# T ECHNICAL INFORMATION

65732  
(Page 1 of 2)

Subject	▶ Change of Spindle
For Models	▶ 9560, 9560C, 9560CV, 9561, 9561C, 9561CV, 9562, 9562C, 9562CV, 9563, 9563C, 9563CV, 9564, 9564C, 9564CV, 9564CVL, 9565, 9565C, 9565CV, 9565CVL
Country	▶ All countries
Description	▶ See below.

▶ Current	▶ New

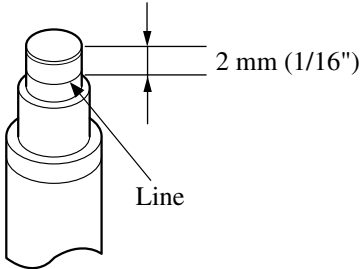
End of Spindle has been changed in dimensions. Use an arbor press to insert a new Spindle into Gear Housing Complete as it is too tight to be inserted by hand. To distinguish the new Spindle from current one, a line has been added on it as shown below. Part No. remains the same.

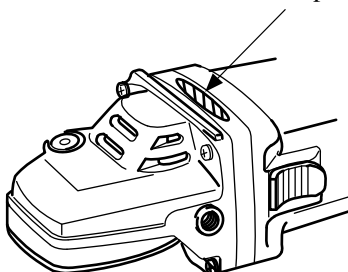
When installing the Gear Assembly on machine body, use a plastic hammer to strike the shaded portion of the machine.

Strike this shaded portion with a plastic hammer.
